Groundwater Transfer Review Summary Form

Transfer/PA # T- 14165

Ground Water Review Form:

Application: T-14165 Applicant Name: Kameron DeLashmutt/Pinnacle Utilities, LLC

Figure 1. Hydrograph of Wells in Cline Buttes Area

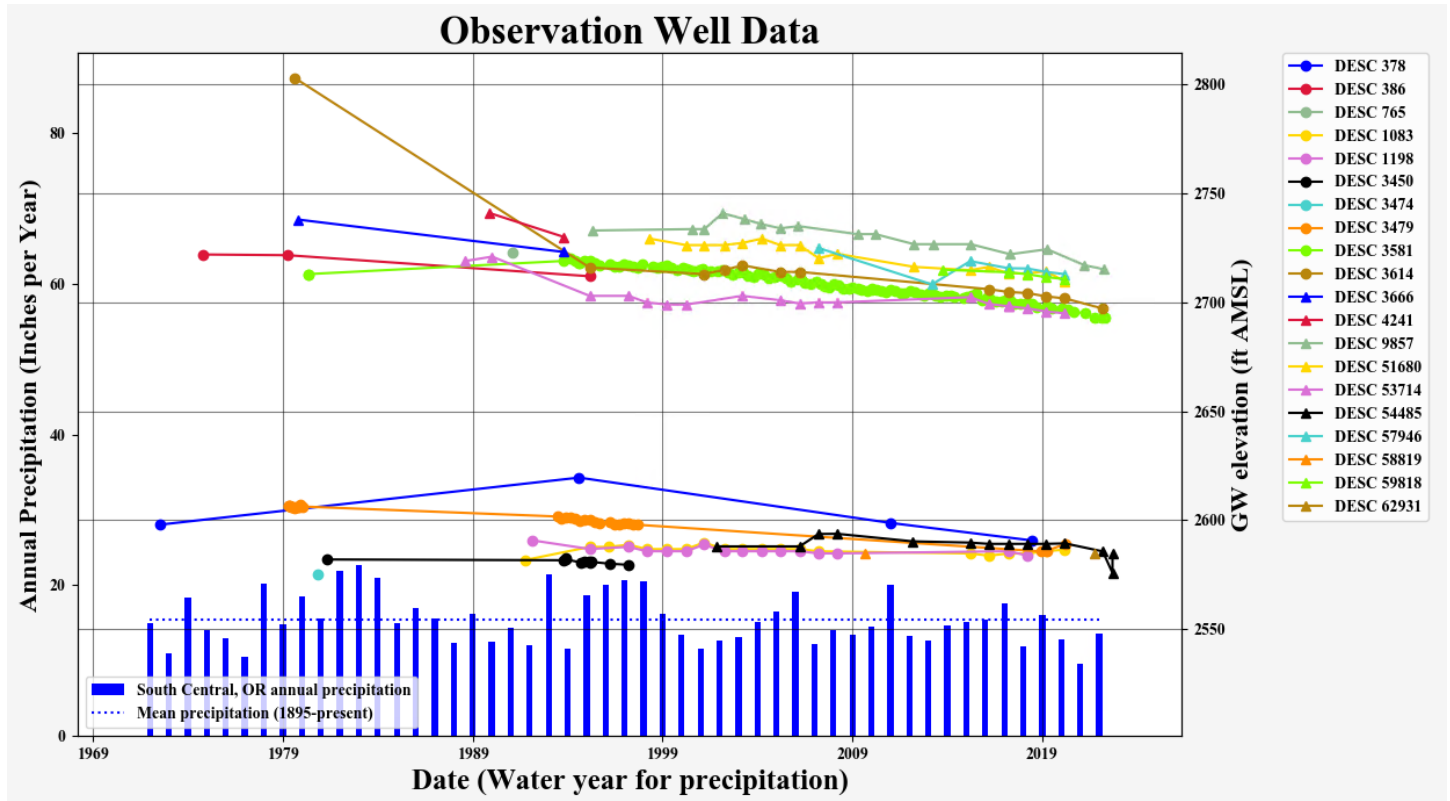
Note: there is a cluster of wells (including but not limited to DESC 378, DESC 1198, DESC 3479, DESC 3474, DESC 54485, and DESC 62931) that are drilled into or are adjacent to the 6.1 MA aged Cline Buttes silicic dome complex and have water levels with a general elevation of 2580-2600 feet AMSL. These wells are surrounded by wells drilled into the Deschutes formation (aged 7.5 to 4.0 MA) with water levels around 2700 feet AMSL. The groundwater depression associated with Cline Buttes is likely caused by a combination of water budget fluctuations (e.g., pumpage and recharge) and a contrast in permeability between the silicic dome complex and the arc-adjacent volcanics of the Deschutes Formation. The exact areal extent of this groundwater depression is not known. However, the available data do not distinguish this zone as a separate aquifer from the Deschutes Formation.

Figure 2. Hydrograph of Wells Near DESC 51145

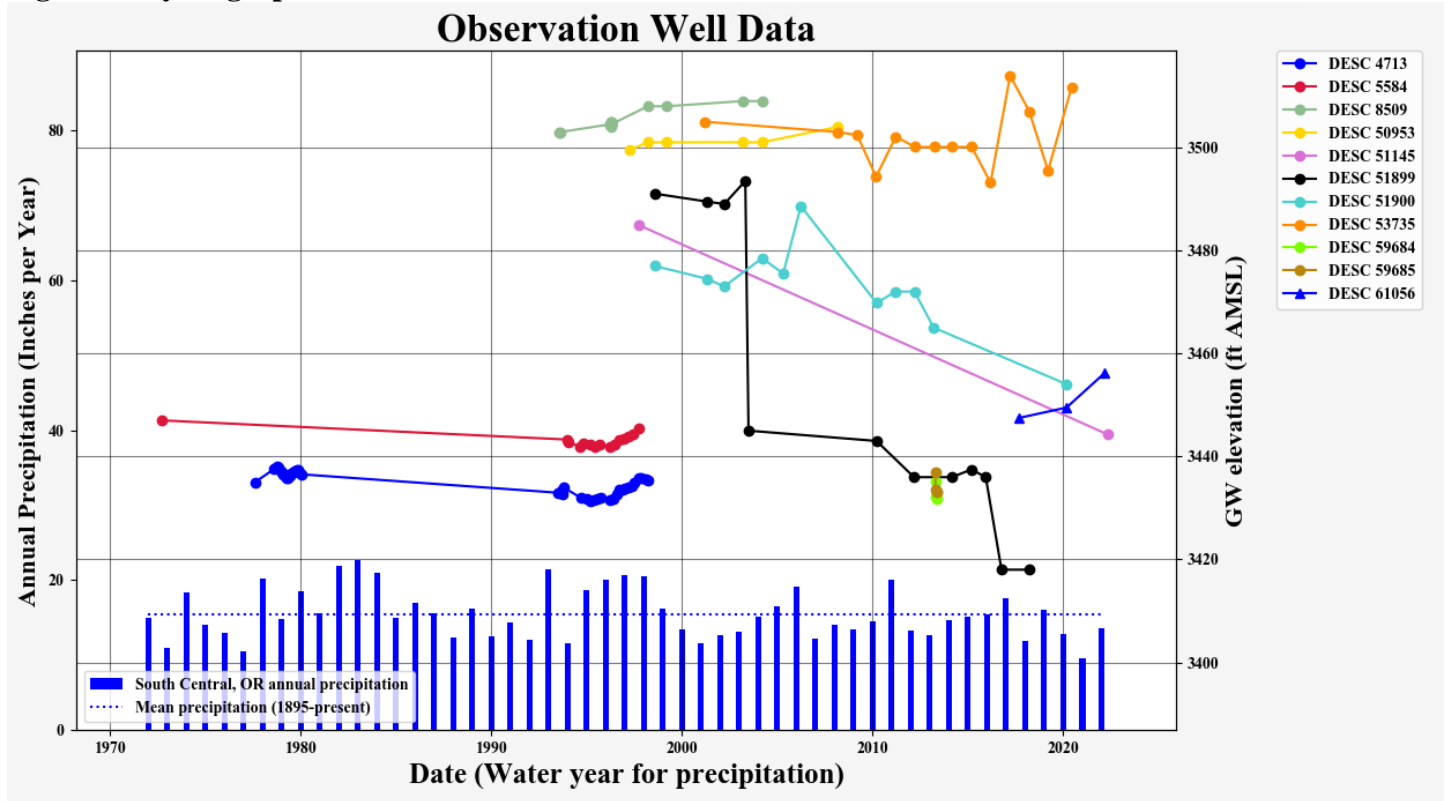
2. Will the proposed POA develop the same aquifer (source) as the existing authorized POA?
 Yes No Comments: DESC 51145 (the “from” well) penetrates Quaternary-aged volcanics erupted from the Cascades and then at depth likely encounters the older volcanic units of the Deschutes Formation, a geographically extensive series of interbedded extrusive volcanics and volcanoclastic sediment from the Cascades and alluvial deposits from the ancestral Deschutes River. There, DESC 51145 accesses the regional aquifer system largely recharged by precipitation in the Cascades and transmitted via the Deschutes Formation. Water levels in the vicinity of the DESC 51145 are typically several-hundred feet below land surface at elevations between 3400 and 3500 ft AMSL. The 7 proposed “to” wells are between 12 and 15 miles north of the current POA but along the regional groundwater flowpath through the middle Deschutes basin. The proposed POAs will also be producing from the Deschutes Formation aquifer system. Water levels in the vicinity of the proposed APOAs are also several-hundred feet below land surface and are generally at elevations between 2600 and 2800 ft AMSL.

Figure 3. Map of Proposed Well Changes.

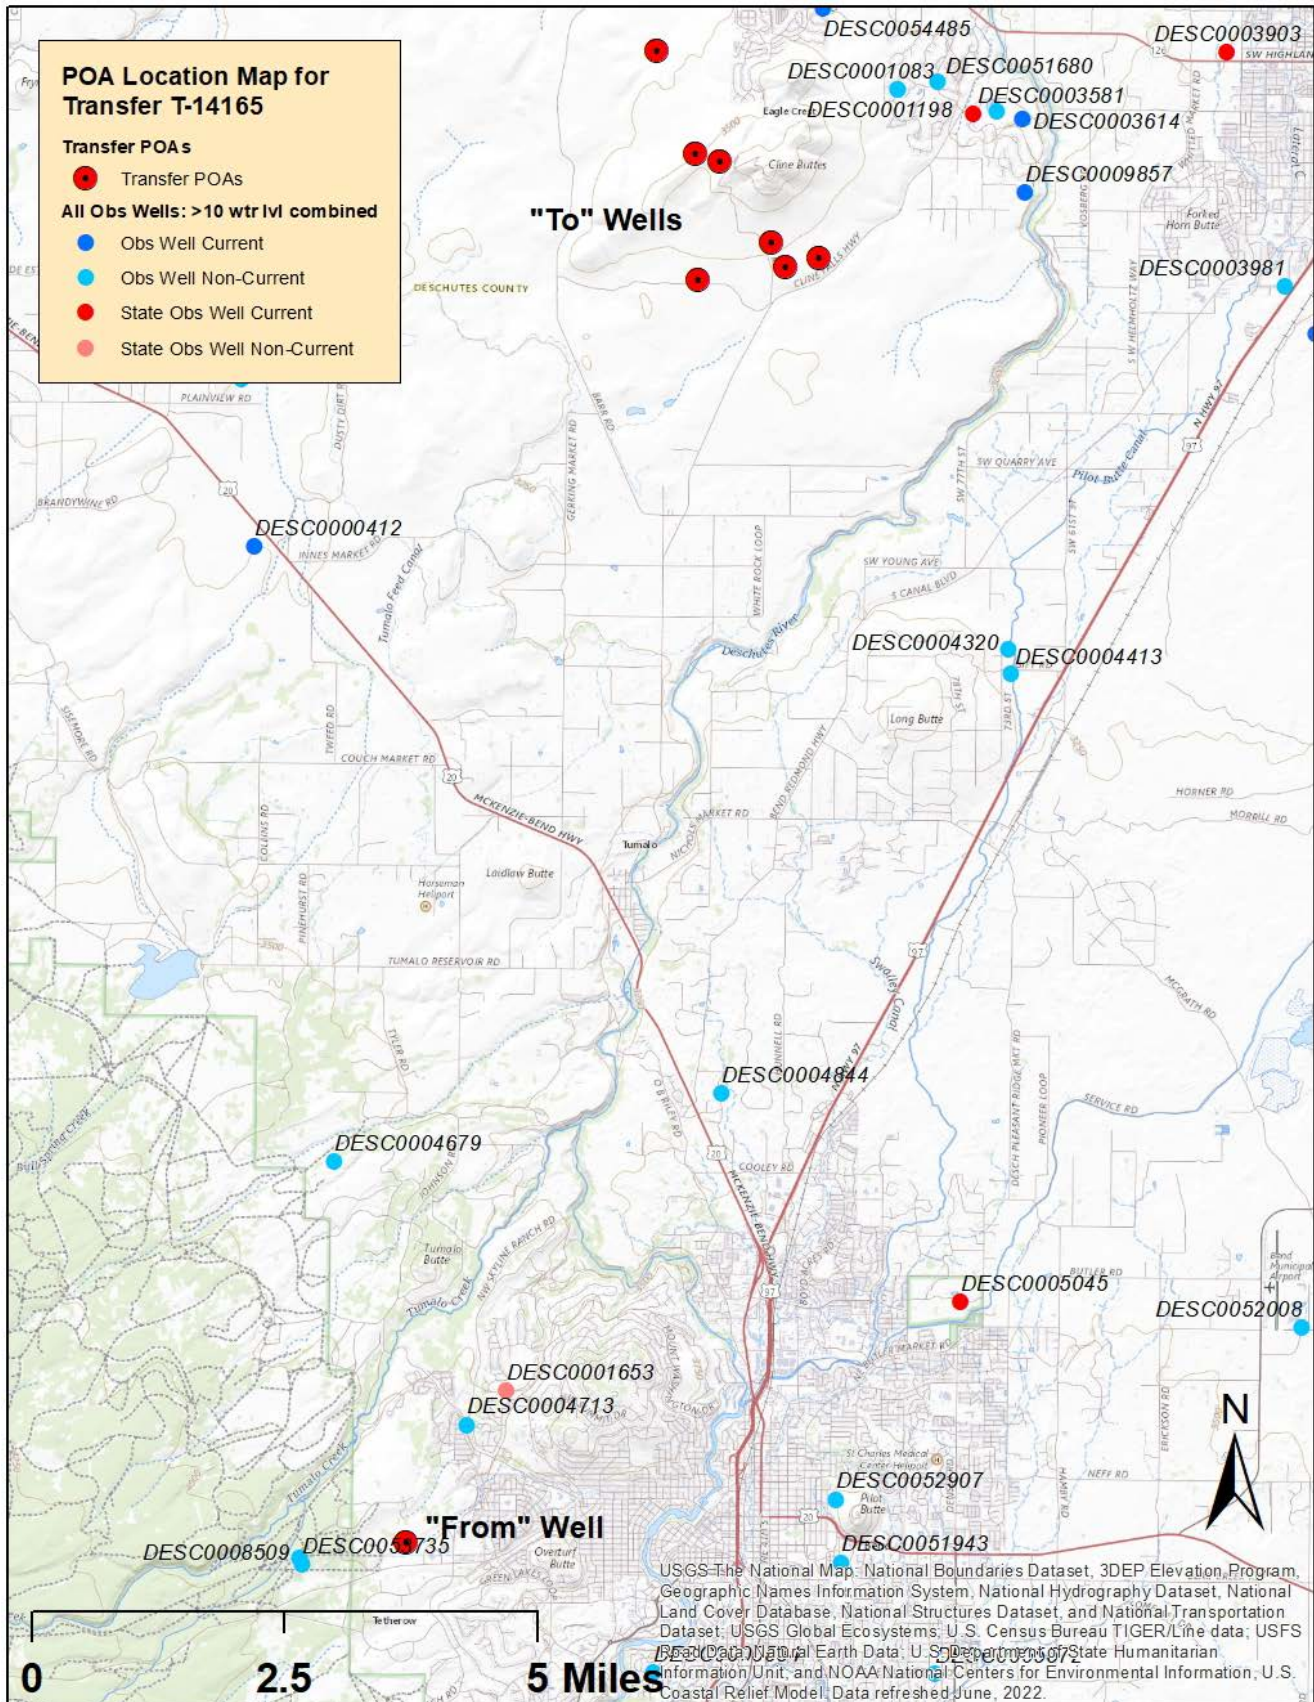
1. Basic description of the changes proposed in this transfer: Certificate 96029 currently authorizes 0.7141 cfs of quasi-municipal use from DESC 51145. The proposed transfer would move 0.453 cfs of production from DESC 51145 under certificate 96029 to 7 undrilled POAs located 12-15 miles to the north and would move a portion of use from the current POU to the location originally associated with permit G-17036.

4. a) Will this proposed change, at its maximum allowed rate of use, likely result in an increase in interference with **another ground water right**?
 Yes No Comments: The proposed change would move the POA approximately 12 to 15 miles from the current location. This will mean that the current right would be seasonally interfering with an entirely separate group of groundwater users that would not be similarly affected by the use at the current POA.
